TECHNICAL SERVICE BULLETIN

Date: 3/6/97

merit industries, inc.

FIGURE 1

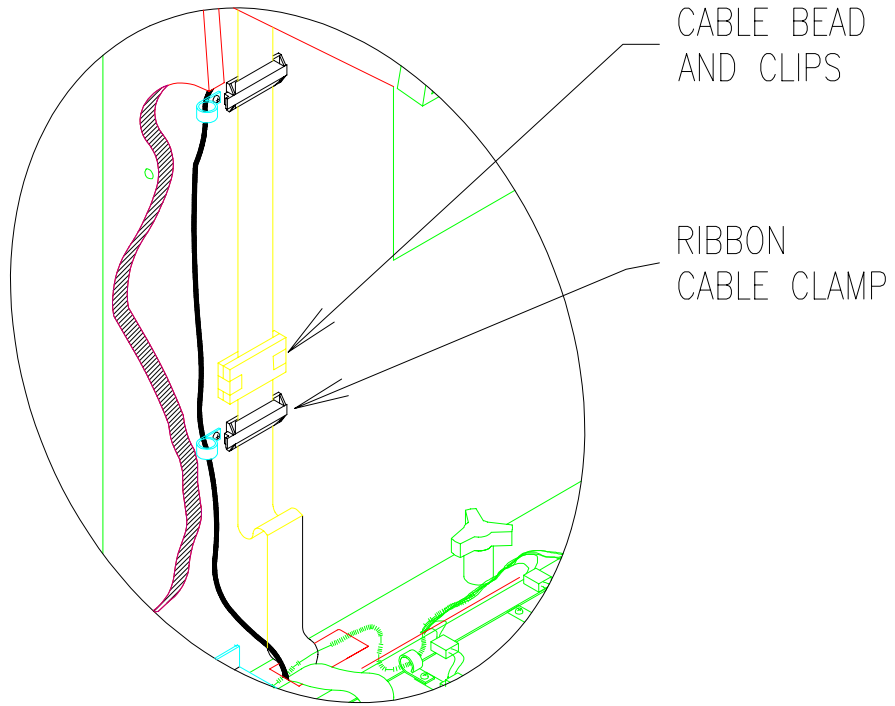
- Problem:** Ribbon cable connector may pierce the ribbon cable going from the CPU to the overhead display.
- Games affected:** Scorpion™ dart games that have had the overhead ribbon cable pierced by the microphone ribbon cable clamp.
- Symptoms:** Overhead display not functioning properly.
- Cause:** The clamp securing the microphone ribbon cable to the RDP28 board may pierce the overhead ribbon cable when the target section door is closed.
- Solution:** Install a piece of lexan over the ribbon cable to protect it.

1. Turn off the power to the game.
2. Open the target section door.
3. Remove the cable bead and clips (shown in Figure 1) and reinstall them below the ribbon cable clamp (shown in Figure 1).
4. Using four (4) wood screws, secure the piece of lexan over the overhead ribbon cable. The bottom edge of the lexan should be approximately 2-1/4" above the ribbon cable clamp. The completed installation is shown in Figure 2. NOTE: WHEN INSTALLING THE LEXAN, BE CAREFUL NOT TO PIERCE THE RIBBON CABLE WITH ANY OF THE SCREWS. ALSO, WITHOUT BOWING THE LEXAN, MAKE SURE THAT THE RIBBON CABLE CAN MOVE FREELY AFTER THE LEXAN IS INSTALLED.
5. Close the target section door.
6. Turn the power on.
